DRAFT list of the Vincent's comments so far—we'll find more, but this is a start. Feel free to use them all or in part when preparing your own comments and let us know what we have missed that we can add to these. The more info we can provide, the better.

We are concerned about how the Northern Rail Extension project may affect our property; the 40 property owners on Fivemile Clear Creek (referred to in the report as Fivemile Clearwater River); the creek itself; hunting, fishing, and recreation for all property owners and users in the area; and access to properties and hunting grounds in the area of the creek. The comments we are providing are in regards to the Tanana River crossing near Salcha, the Central Alternatives 1 and 2, and the associated connectors. Specifically, our comments are:

Figure 2-17 - Salcha Alternative Segment 2 Tanana River Crossing

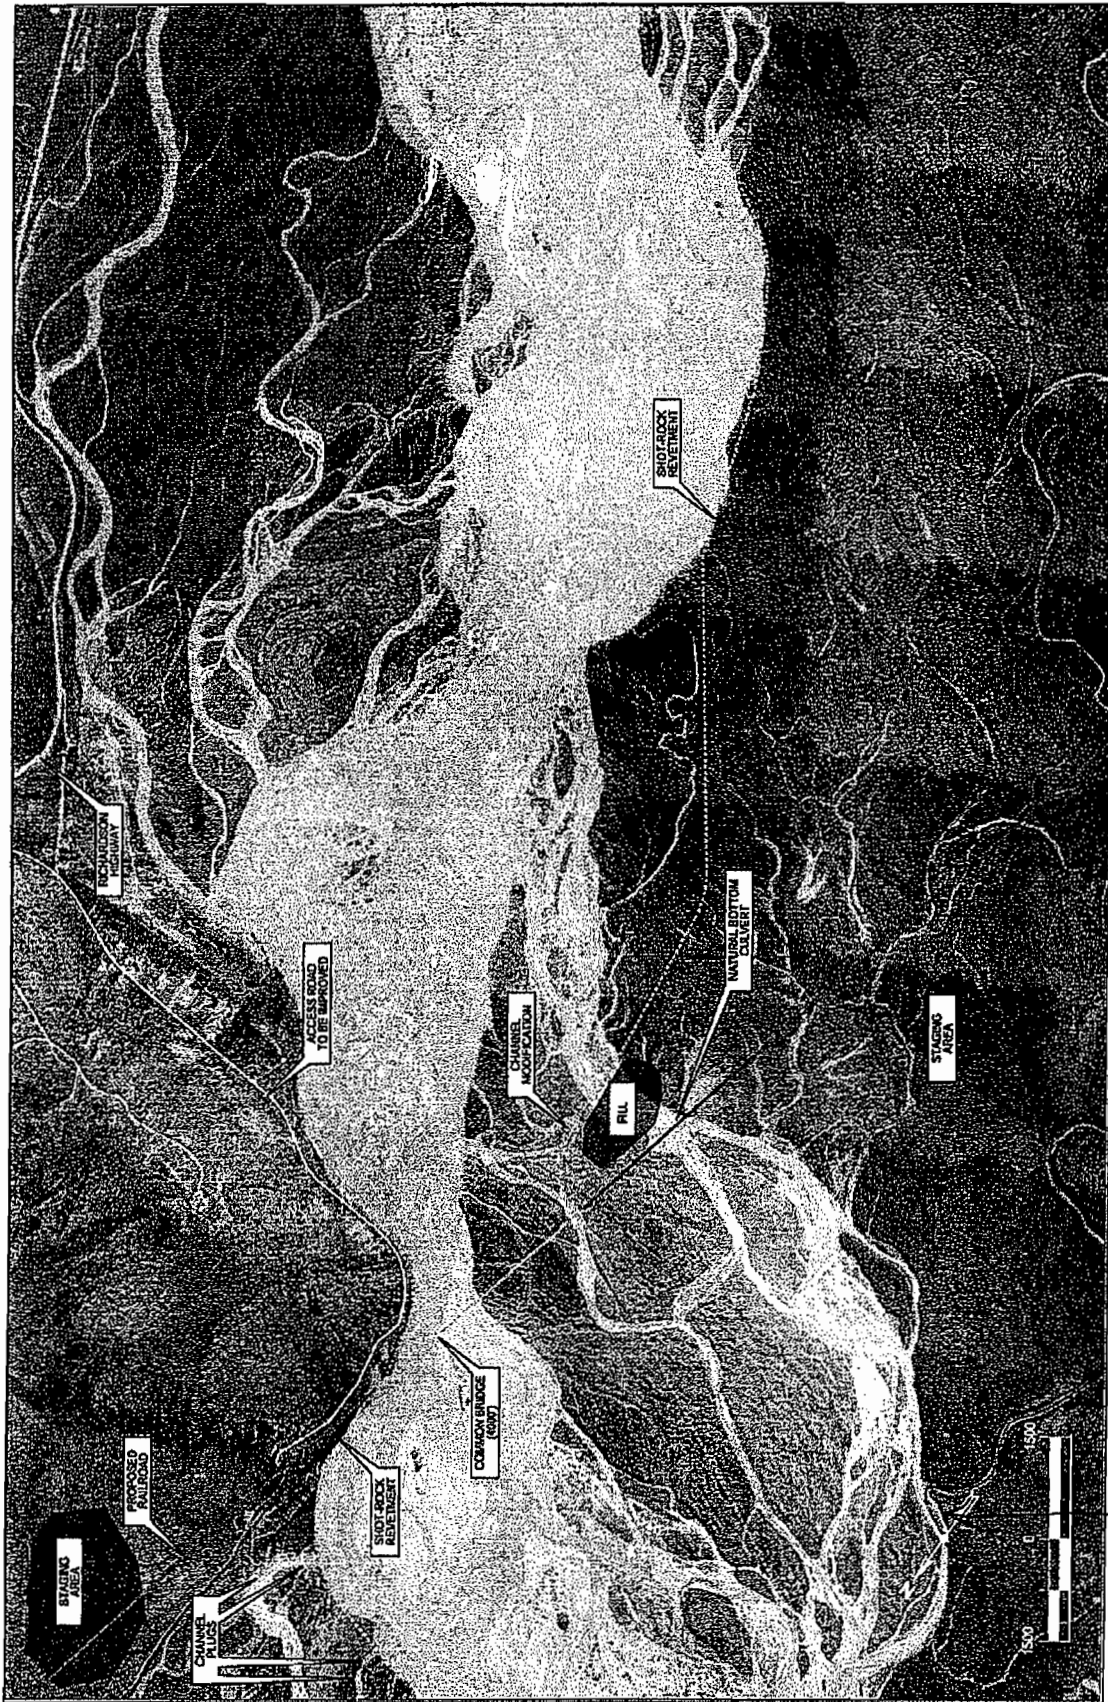
1. Figure 2-17, Tanana bridge Alternative 2, shows a channel blocked with "fill" on the west side of the Tanana to accommodate the bridge. This is the channel that is used to access the mouth of Clear Creek. Creek flow would not likely be enough to maintain navigability as it spreads over the wide channel bed, so blocking Tanana flow to this channel would cut off summer access to the creek and the 40 properties on it. There is no other reasonable summer access to the creek. Additionally, in reference to this same figure, are concerns about what impact this will have to the fish population on the creek. The grayling migrate annually, and there are annual salmon runs. This alternative could be detrimental to both, thereby leading to serious environmental concerns further up the food chain.

Figure 13-4 – Map of Recreational Facilities along the Salcha, Connector, and Central Alternative Segments

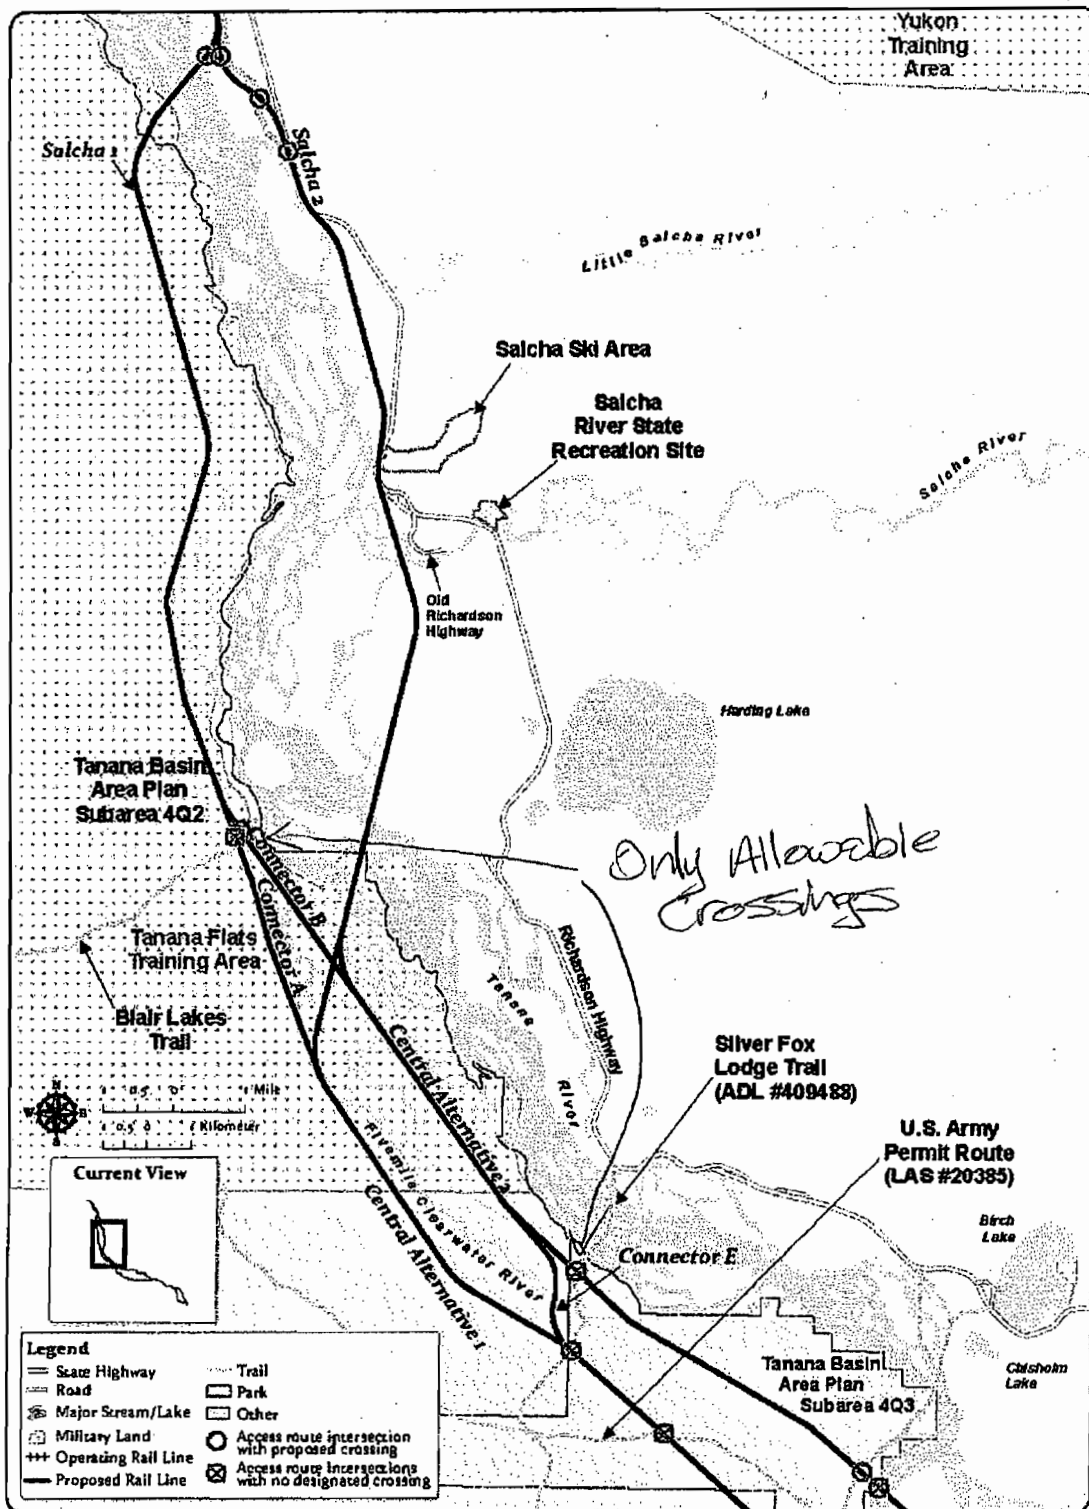
2. a. Figure 13-33 shows one allowable crossing of railroad line near the headwaters of the creek and one near the mouth of the creek. According to this Draft EIS, crossing the railroad line will not be allowed in other locations. This cuts off winter access to most properties on the creek. The creek doesn't freeze in the winter, so the creek cannot be used as a trail from the crossings upstream or downstream to the properties. Landowners have built their own winter trails where they are needed to access their properties. Drawing a line across these cuts off their winter access to their properties.
